WATER PERMIT NO. 8587-3

SOUTH DAKOTA
WATER PERMIT NO. 8587-3

**REVISED RECOMMENDATION OF CHIEF ENGINEER FOR WATER PERMIT
APPLICATION NO. 8587-3, Justin Christianson**

Figure 1: Map showing the approximate extent of the erosional remnant of the Niobrara Formation this application proposes to use and the first occurrence of bedrock material (modified from Tomhave and Schulz, 2004 and Holmes and Filipovic, 2015)

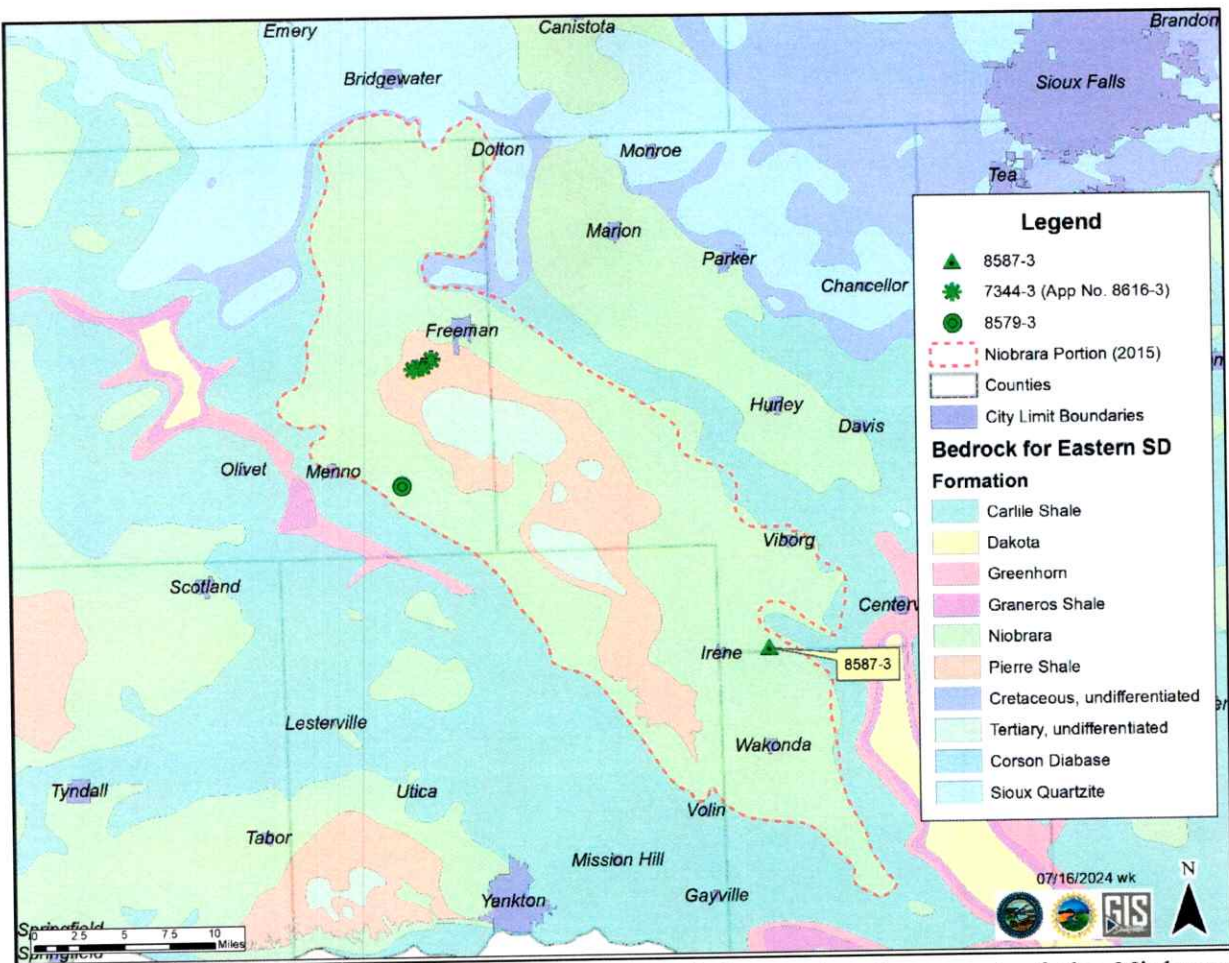
There are several applications undergoing review related to this portion of the Niobrara aquifer, which are summarized in Table 1 with locations shown in Figure 1. The initial test holes for this application indicated the target aquifer was a sand and gravel aquifer likely overlaying the Niobrara Formation. Mathiowetz (2022) initially reviewed this application in March 2022 and found there was not sufficient information available to evaluate the sand and gravel aquifer. The Chief Engineer recommended deferral of this application for an aquifer pump test or change of aquifer, then the applicant put the application on hold to consider their options. An additional test hole was drilled in January 2024, which led the applicant to update the application to the target aquifer being the Niobrara aquifer. This application is now being reviewed for the updated target aquifer.

As part of this application, reports for five test holes, two monitoring wells, and one 12-inch irrigation well; with completion dates spread over the period of several years (2021-2024) were submitted to the Water Rights Program. The irrigation well was completed into gravel from 50-97 feet below grade with a static water level (April 2022) at 47 ft below grade; indicated the aquifer at the well site is under confined conditions. The January 2024 test hole indicated that the

top of the chalk was encountered at 31 feet below grade. The January 2024 test hole is consistent with the approximate depth to the top of the bedrock in the area (Tomhave and Schulz, 2004; Jensen, 2015). Mathiowetz (2024) after reviewing the drilling information, available geology information, and discussion with the driller determined the sand and gravel deposits encountered in the 2021 and 2022 borings were likely isolated deposits of sand and gravel intermingled with and surrounded by the upper portion of the Niobrara Formation. Based on this Mathiowetz (2024) determined that, “based on the best available information, the sand and gravel deposits previously encountered are discontinuous and may even be functioning as a portion of the Niobrara aquifer and should be considered as such.”

Figure 2: Hydrographs for observation wells monitoring this portion of the Niobrara aquifer with over 20 years of data (Water Rights, 2024c).

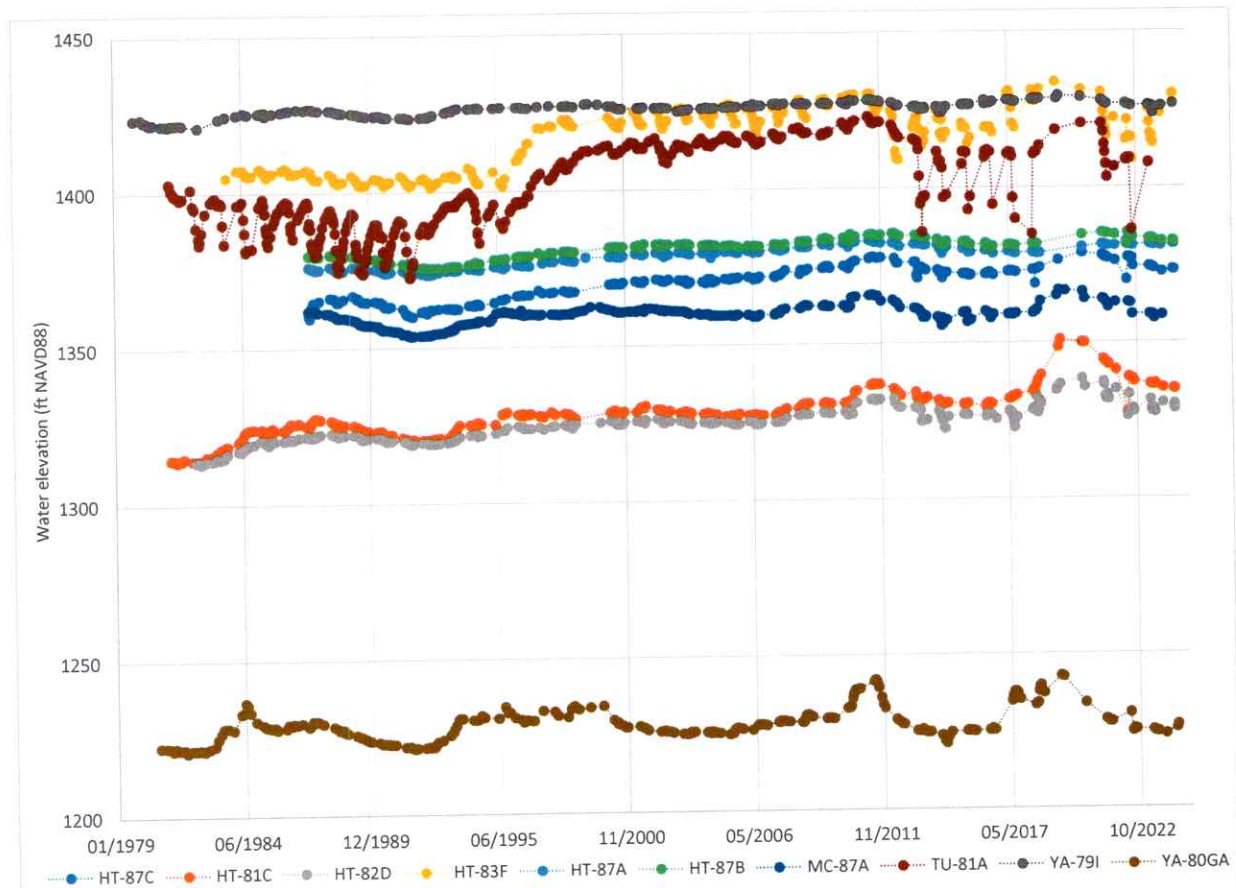
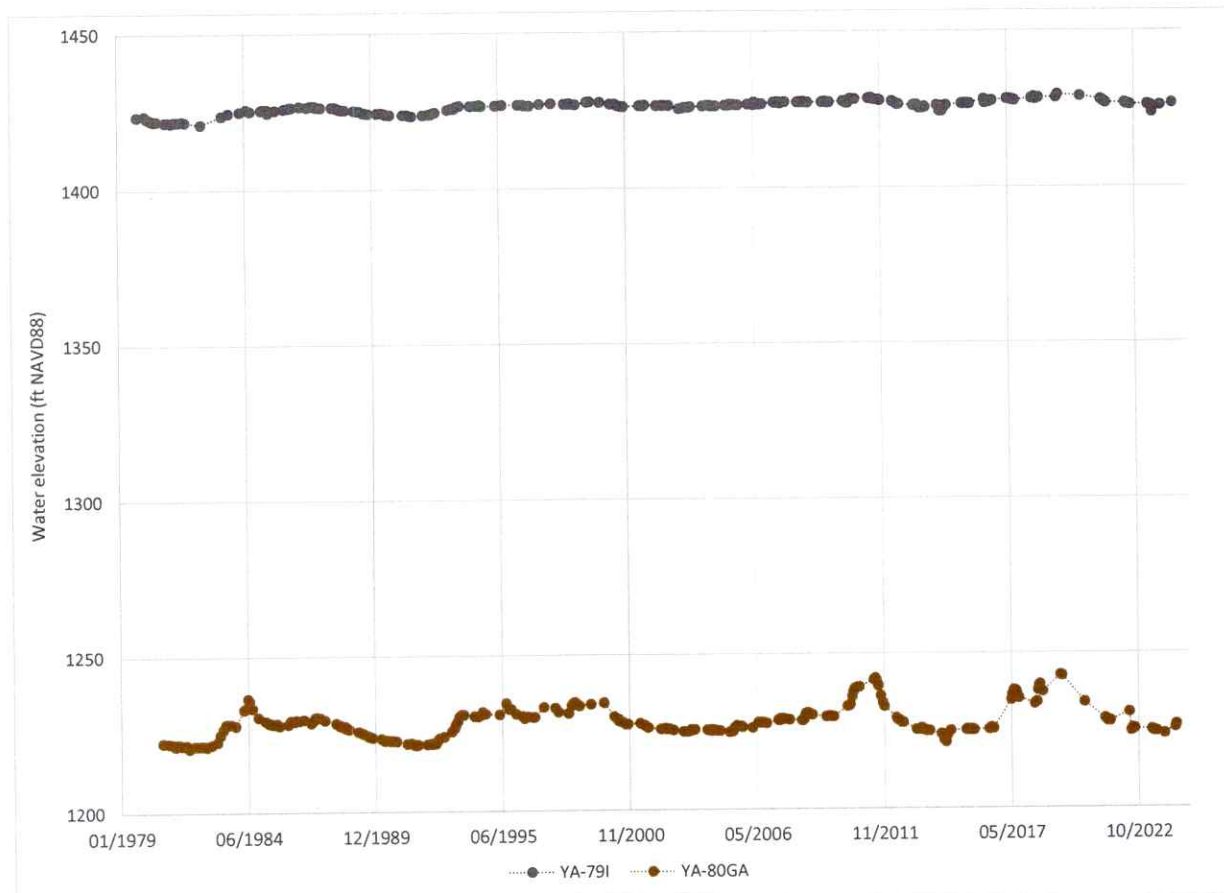
The hydrographs shown in Figures 2 and 3 show stable to slightly increasing water level trends in this portion of the Niobrara aquifer over the period of record. Observation well YA-79I is located 6.7 miles to the north-northwest of the well site for this application and Observation well YA-80GA is located 6.9 miles to the south-southwest of the well site for this application. The magnitude of shorter period fluctuations in response to wet and dry climatic cycles varies between observation wells. For example, see the variation in the hydrographs for observation wells YA-79I and YA-80GA. Several observation wells (for example HT-83F and TU-81A) in close proximity to irrigation wells show localized seasonal dips in measured water levels during the irrigation season in response to pumping (Water Rights, 2024b and 2024c). This is representative of the artesian head pressure of the aquifer in the area responding to seasonal irrigation pumping. However, water levels recover after the end of the irrigation season when pumping ends.

Water levels in the observation wells monitoring this aquifer generally rise during wet periods and decline to stable levels during drier periods. This type of behavior, along with aquifer recovery following the irrigation season, is indicative that climatic conditions, and therefore the effects of recharge to and natural discharge from the aquifer, govern the long-term fluctuations in

water levels in the aquifer instead of pumping. Since recharge to and natural discharge from an aquifer can be captured for pumping, there is a reasonable probability that unappropriated water is available from this portion of the Niobrara aquifer for the proposed appropriation.

Figure 4: Location of observation wells monitoring this portion of the Niobrara aquifer (Water Rights, 2024c)

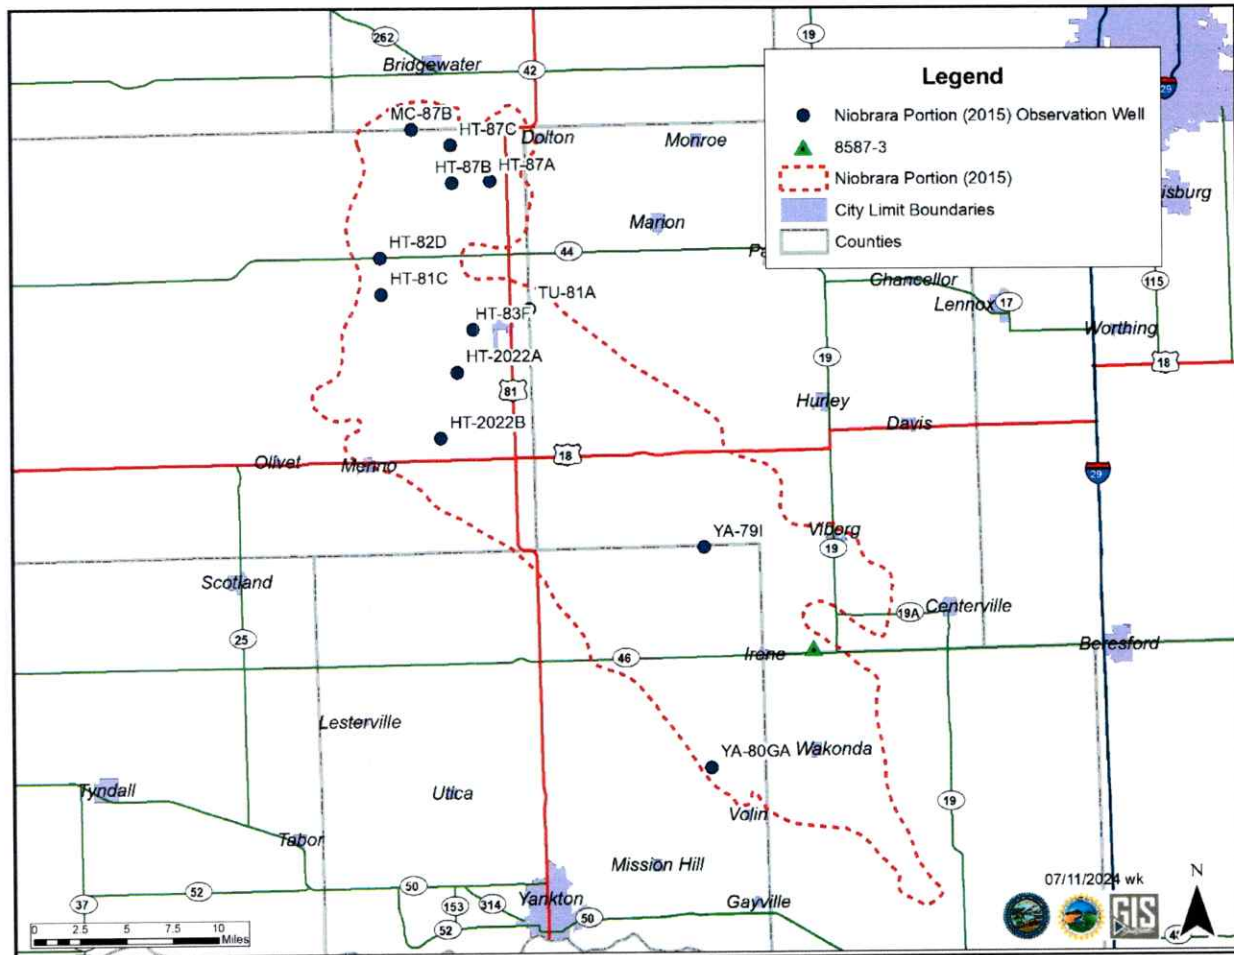
The DANR Water Rights Program monitors 13 observation wells completed into this portion of the Niobrara aquifer (Water Rights, 2024c). Two of those observation wells (HT-2022A and HT-2022B) were installed in 2022 and have a limited period of record, so their data is of limited usefulness in evaluating long term water availability and therefore not presented. The rest of the observation wells hydrographs are shown in Figure 2, the hydrographs for observation wells within ten miles are in Figure 3, and the location of all observation wells is shown in Figure 4.

Figure 5: Niobrara water rights/permits in the area of the well site for this application (Water Rights, 2024b and modified from Holmes and Filipovic, 2015)

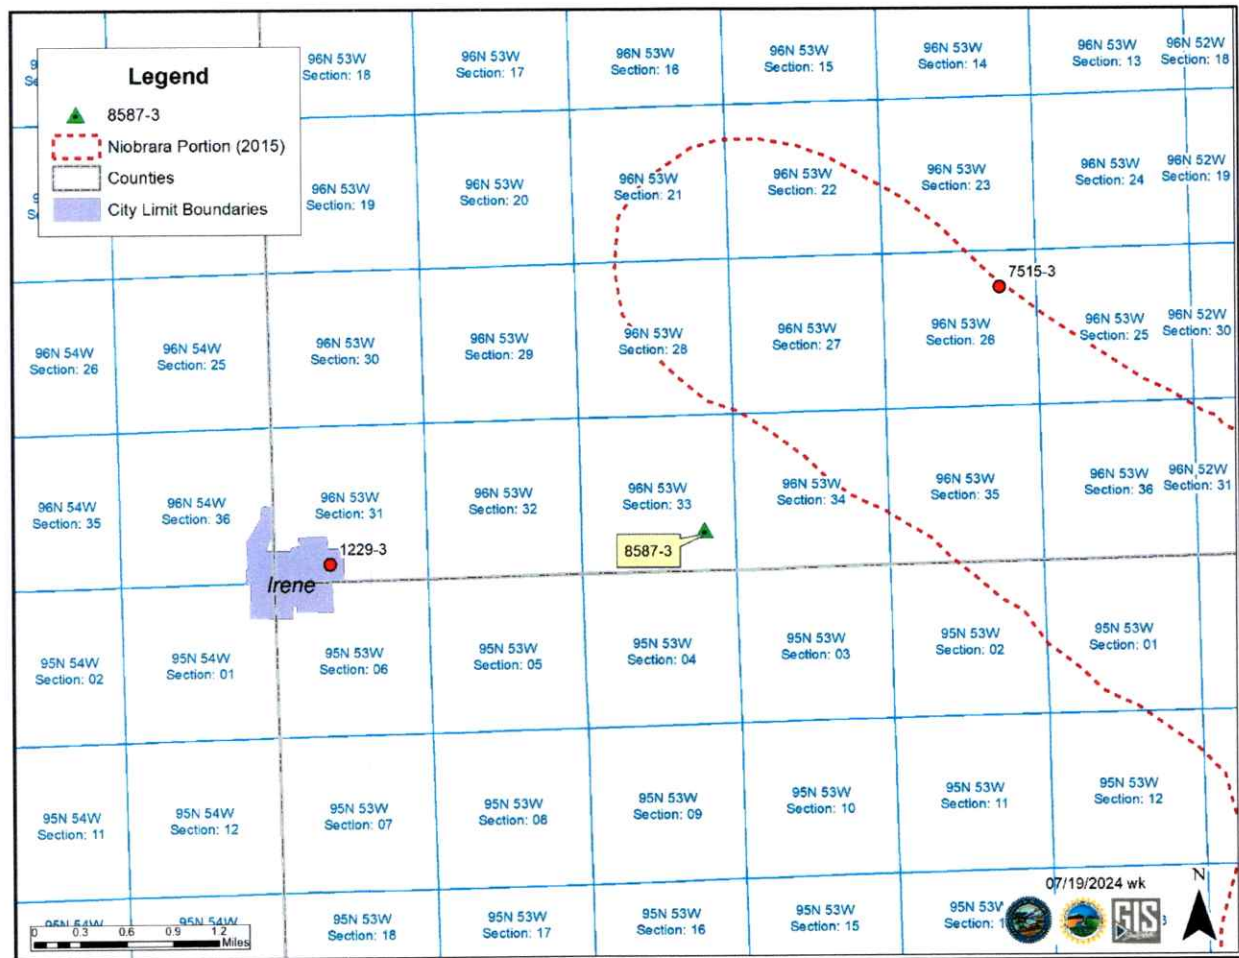
Area water rights/permits completed into this portion of the Niobrara aquifer are shown in Figure 5 and summarized in Tables 2 and 3. The nearest water right/permit to the well site for this application is Water Right No. 1229-3 for the Town of Irene located approximately 2.4 miles to the west, which is connected to rural water. The next nearest water right/permit is Water Permit No. 7515-3 for irrigation located 2.5 miles to the northeast. The nearest domestic well on file with the Water Rights Program (not under the last name of Christianson) was drilled in 1982 located approximately 1.2 miles to the north-northwest based on the legal location provided by the well driller. There could potentially be other domestic wells completed into the Niobrara aquifer near the proposed diversion point that are not on file with the DNR-Water Rights Program.
